# IRC - Building

## 2016 GROUP B PUBLIC COMMENT AGENDA

OCTOBER 19 - OCTOBER 25, 2016  
KANSAS CITY CONVENTION CENTER  
KANSAS CITY, MO

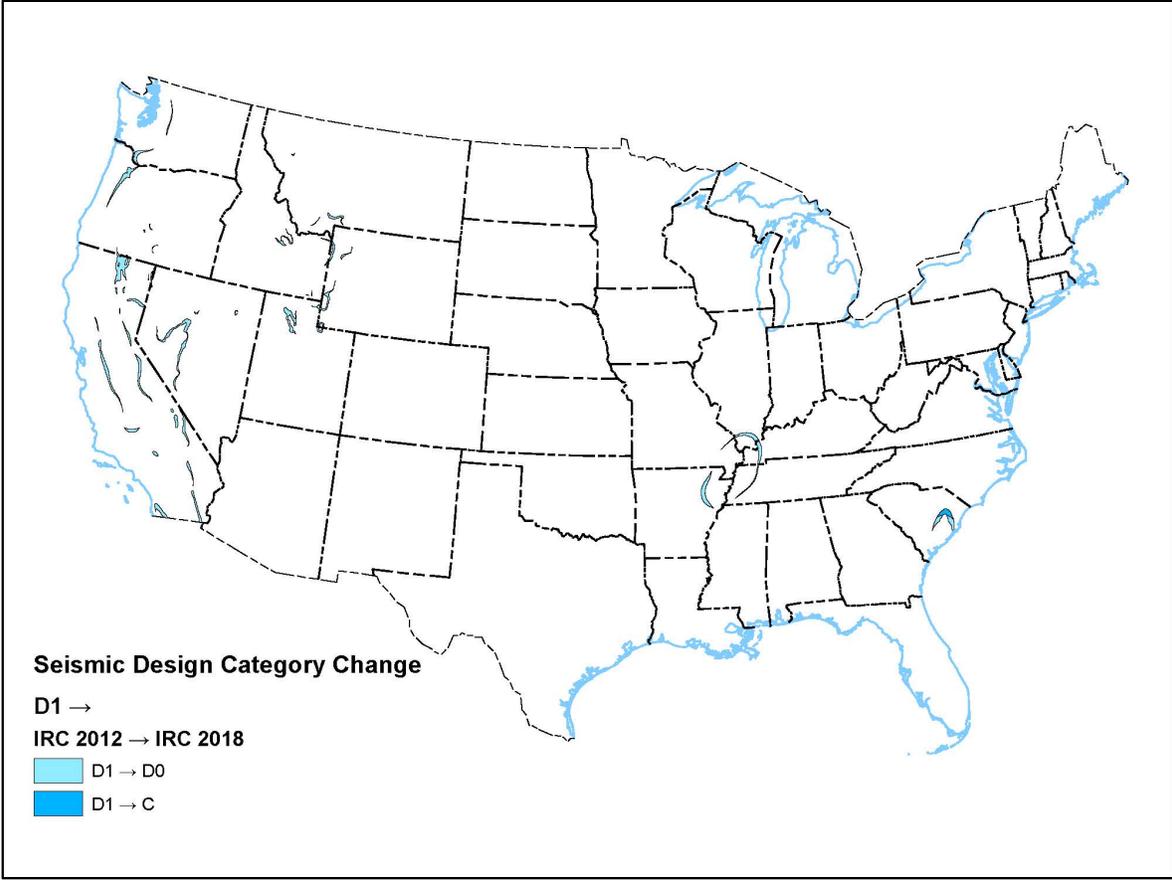
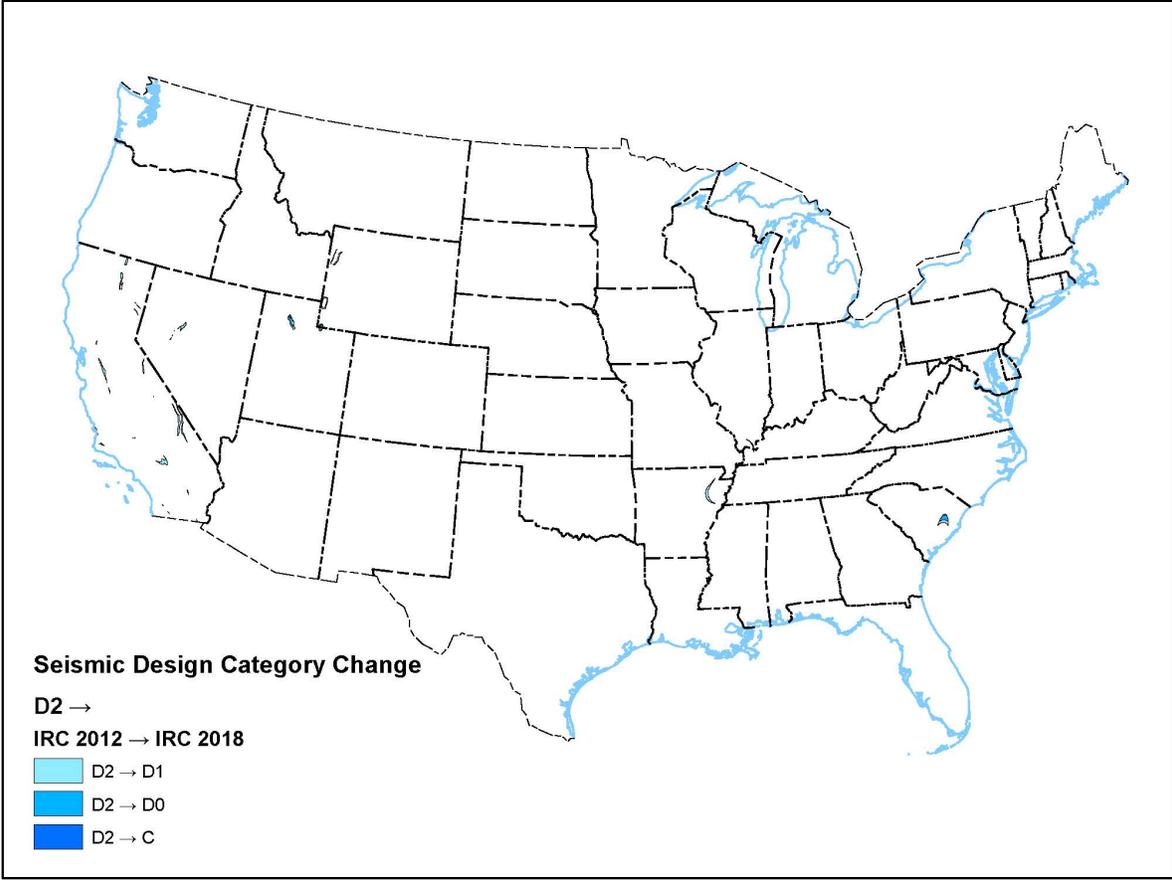
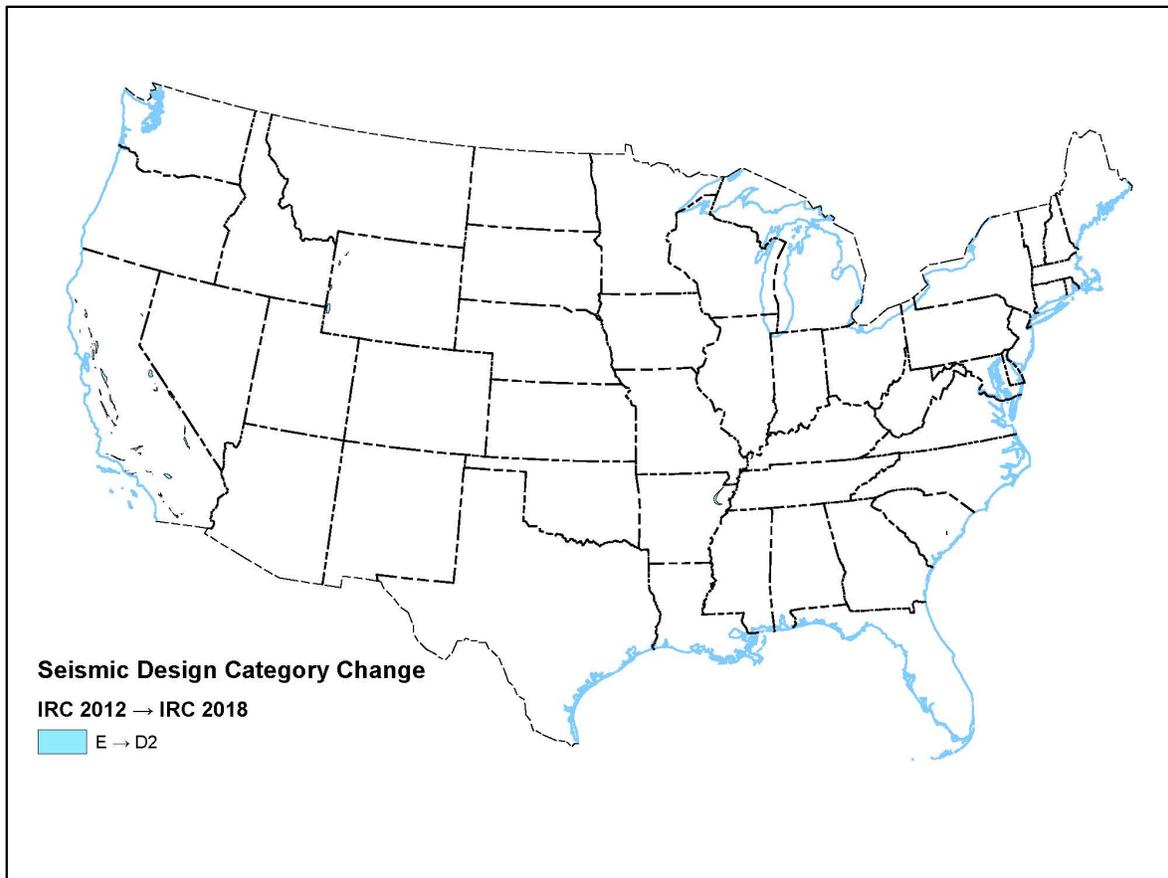
Maps have been developed by USGS to illustrate locations where Seismic Design Categories increase and decrease when comparing the 2015 IRC maps to the R301.2(2) default maps. These are included as an attachment to this code change proposal. Seyhan and Stewart (2014) and Luco et al. (2015) provide discussion of maps changes at some specific locations, including a region near Charleston, South Carolina where Seismic Design Category increased from D<sub>2</sub> to E. This increase is due to changes in both site coefficients and mapped ground motions, the latter due to an improved earthquake source model for the Central and Eastern United States developed through a three and one-half year collaboration of approximately 35 experts (<http://www.ceus-ssc.com>).

This code change can result in modest increases OR decreases in construction cost depending on geographic region. Where the R301.2(2) Seismic Design Category maps are used, limited locations as illustrated by the attached USGS maps, will increase or decrease in Seismic Design Category, increasing or decreasing seismic bracing requirements and cost a modest amount. The amount of increase will vary depending on the specific change in Seismic Design Category, the wind bracing requirements, and the particulars of the dwelling and its construction. In some cases increases in Seismic Design Category and resulting cost can be reduced if not eliminated where the site soils allow the use of the Alternate Seismic Design Category maps. NIST GCR 14-917-26, *Cost Analyses and Benefits for Earthquake-Resistant Construction in Memphis, Tennessee*, provides one example of the magnitude of seismic design cost impact; the increment in cost for apartment building construction between design for code-required wind loads and national seismic design provisions is on the order of one percent of construction cost.

**FIGURE R301.2(4)A**  
**A ULTIMATE DESIGN WIND SPEEDS**

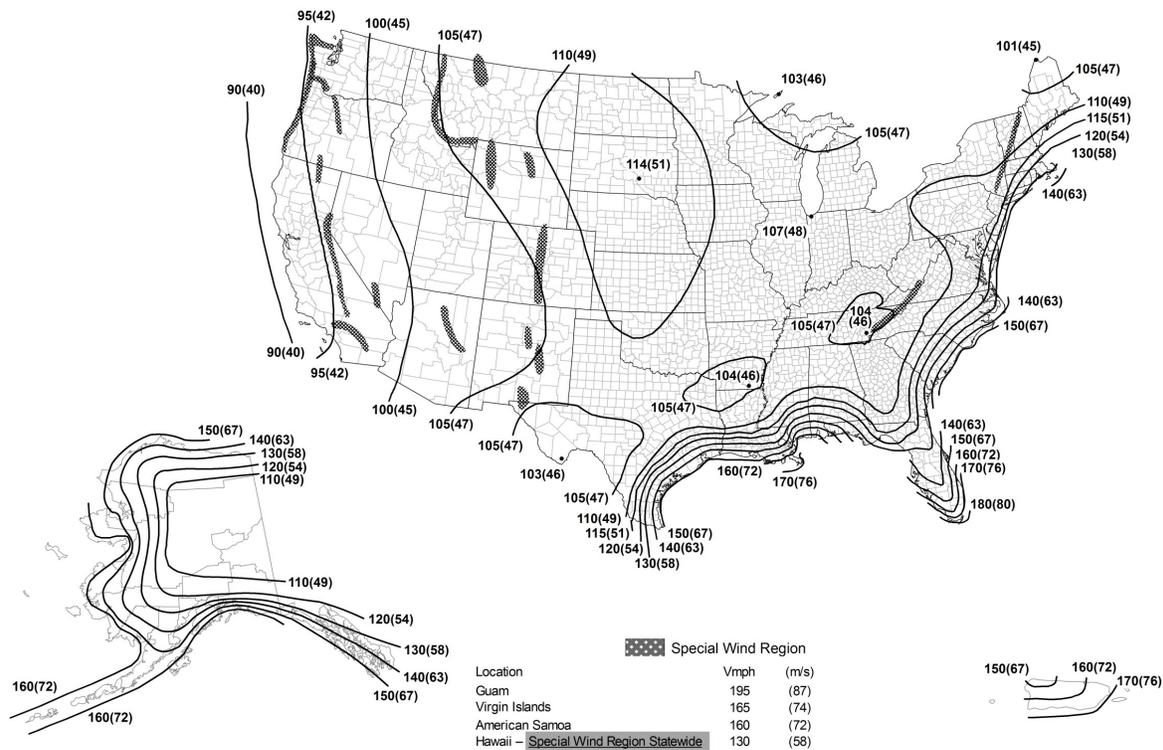
The simplified component and cladding loads in Table R301.2(2) are proposed to be revised for correlation with the new roof component and cladding loads for buildings with mean roof heights less than or equal to 60 feet. The roof zones and pressure coefficients in Figure 30.4-2 (Figures 30.4-2A through 30.4-2I) have been revised based on an analysis of an extensive wind tunnel database. All source data used in the study are publicly accessible through the National Institute of Standards and Technology's website. Compared to previous versions of ASCE 7, the pressure coefficients have been increased, and are now more consistent with coefficients for buildings higher than 60 ft. Roof zone sizes are also modified from those of earlier versions in order to minimize the increase of pressure coefficients in zones 1 and 2. The data indicate that for these low-rise buildings, the size of the roof zones depend primarily on the building height, h. The GCP values given in

Figures 30.4-2A through 30.4-2I are associated with wind tunnel tests performed in both Exposures B and C. For Figure 30.4-2A, the coefficients apply equally to Exposure B and C, based on wind tunnel data that show insignificant differences in (GCp) for Exposures B and C. Consequently, the truncation for Kz in Table 30.3-1 of ASCE 7-10 is not required for buildings below 30 ft, and the lower Kz values may be used as shown revised in Figure R301.2(3) of the IRC.

**FIGURE AH106.4.1**  
**Ultimate Design Wind Speeds for Patio Covers and Screen Enclosures**

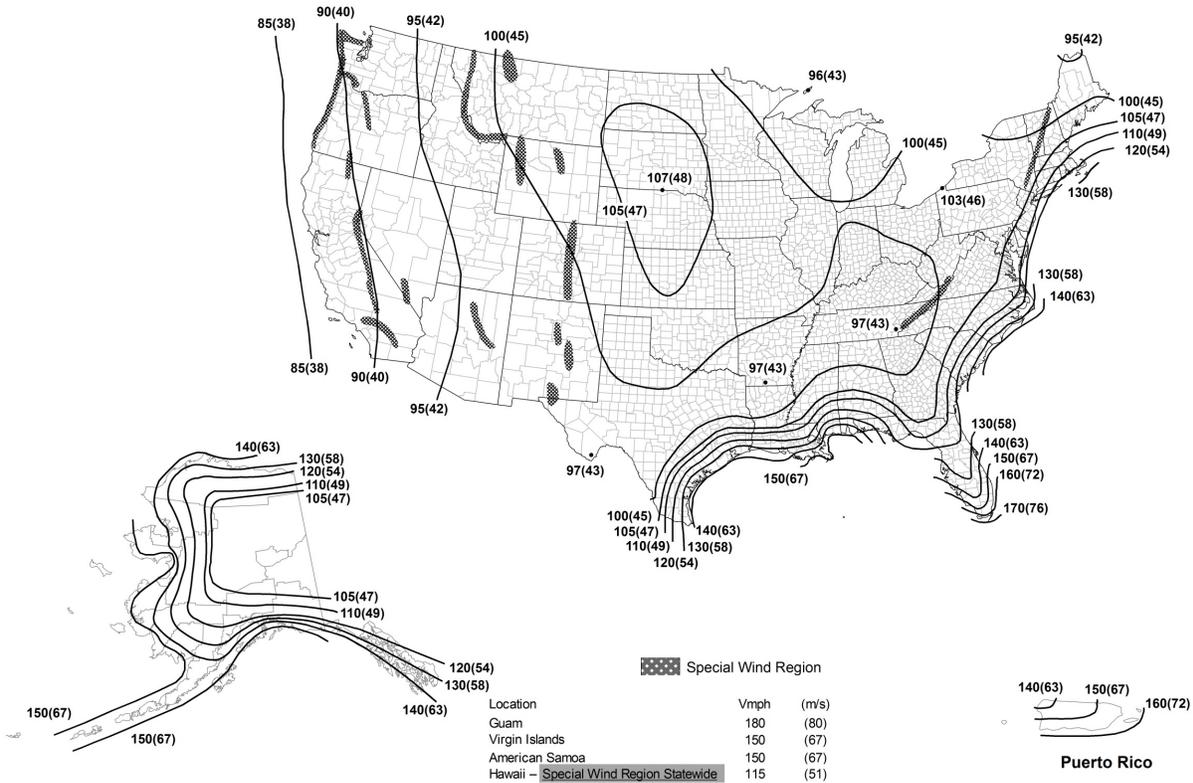
**Committer's Reason:** This proposal coordinates the wind design criteria in the IRC with the wind design criteria (ASCE 7-16) already recommended for inclusion in the IBC. This public comment submission includes an updated design wind speed map for Risk category II buildings, replacement Tables R301.2(2) and R301.2(3) that are consistent with ASCE 7-16, as well as edits to a number of additional IRC provisions that address the lower design wind speeds contained in the ASCE 7-16 design wind speed map. This addresses the objection about completeness of revisions raised by NAHB at the Committee hearings.

Figure 1: UNDER-SLAB BELOW-GRADE INSULATION

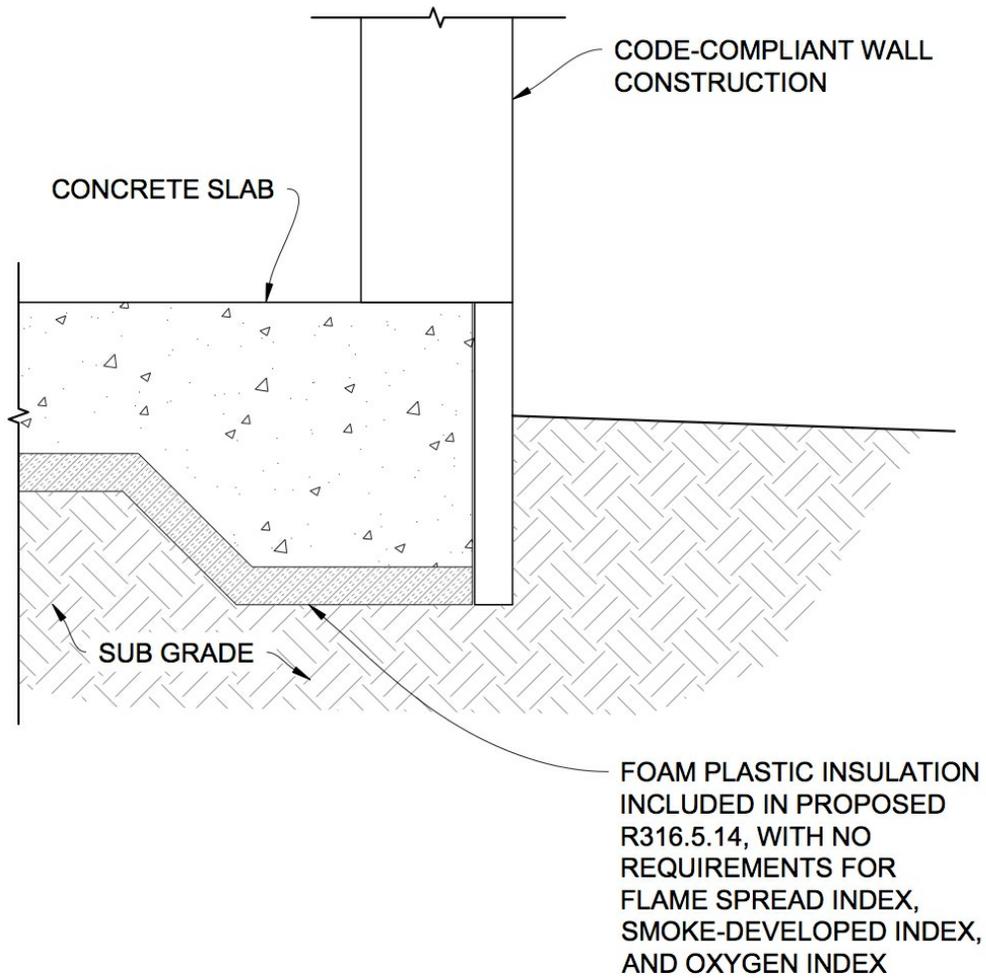
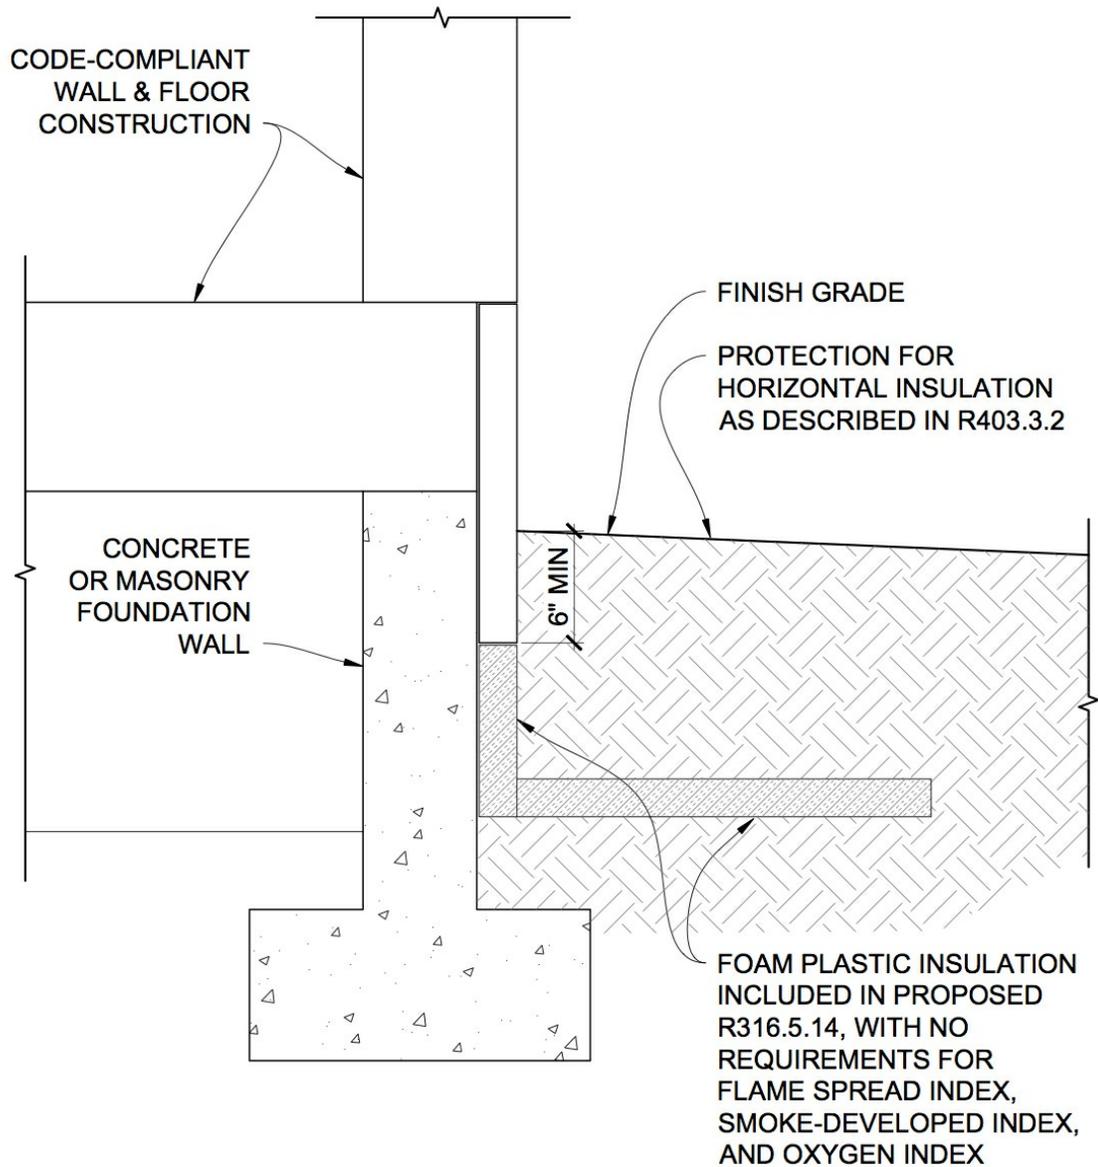
**Figures 1 and 2** depict examples of installations where the proposed code section could be applied. These include insulation between a concrete slab on grade and its subgrade and exterior insulation for basement and foundation walls and frost-protected shallow foundations.

Figure 1: UNDER-SLAB BELOW-GRADE INSULATION  
Proposed Code Section R316.5.14

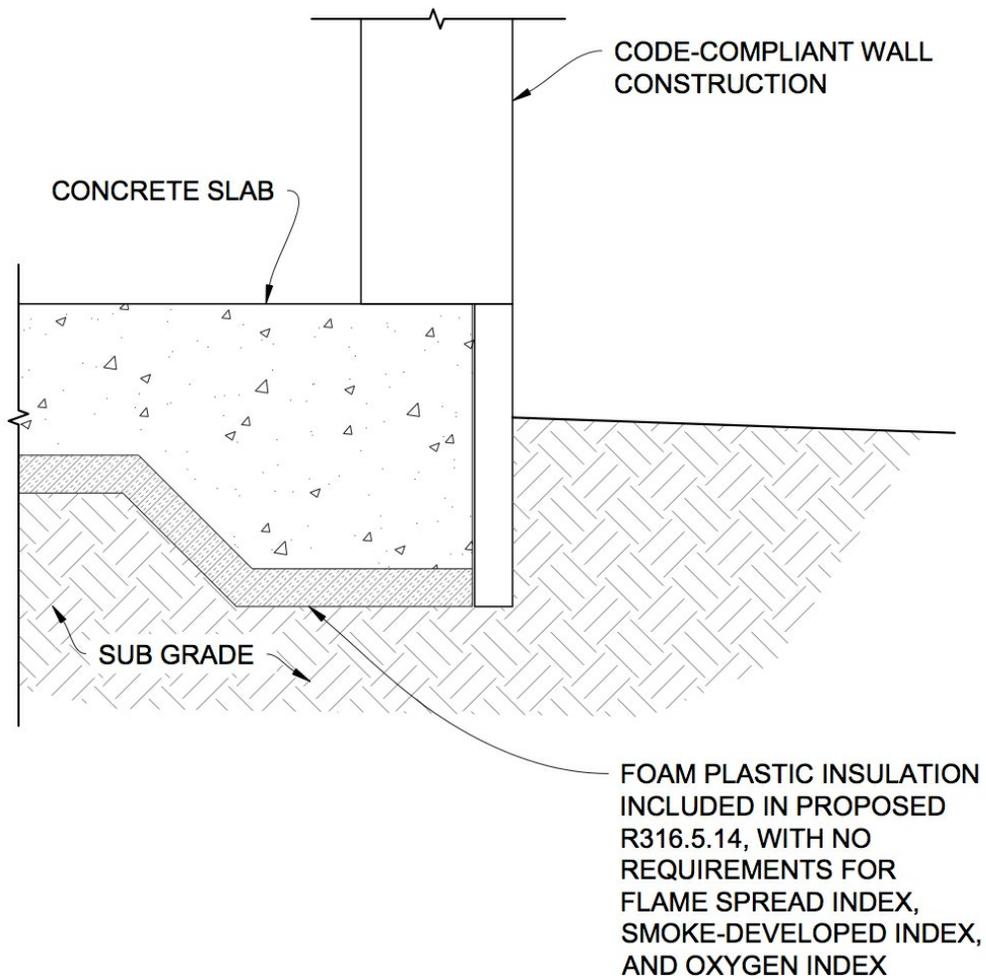
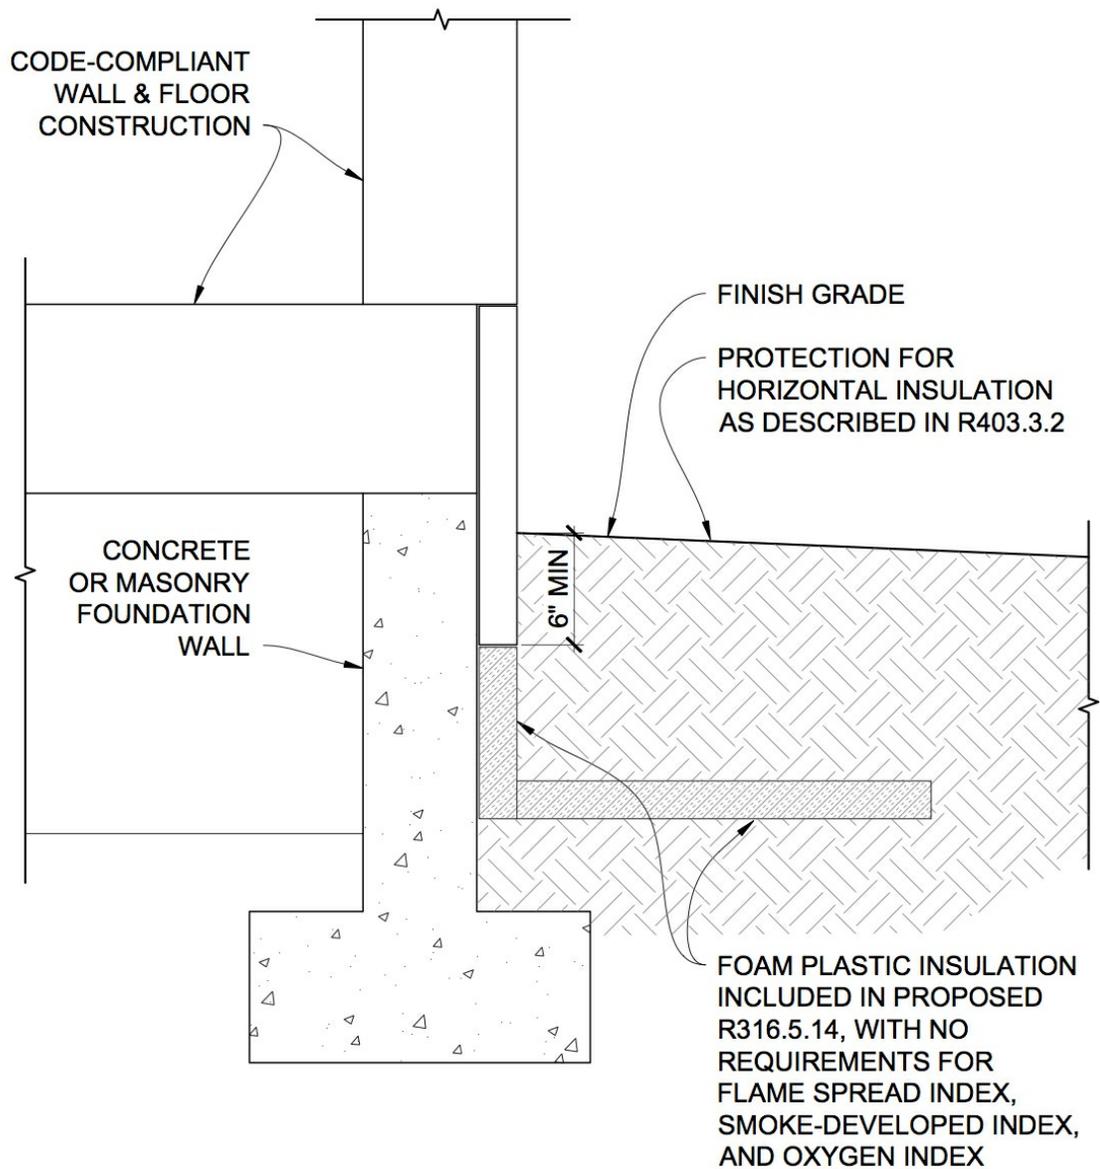
considered adequate for protecting insulation throughout the course of use, and are described in detail in the original Reason Statement for RB152-16 submitted in January 2016. **Figures 1 and 2** depict examples of installations where the proposed code section could be applied. These include insulation between a concrete slab-on-grade and its subgrade and exterior insulation for basement and foundation walls and frost-protected shallow foundations.
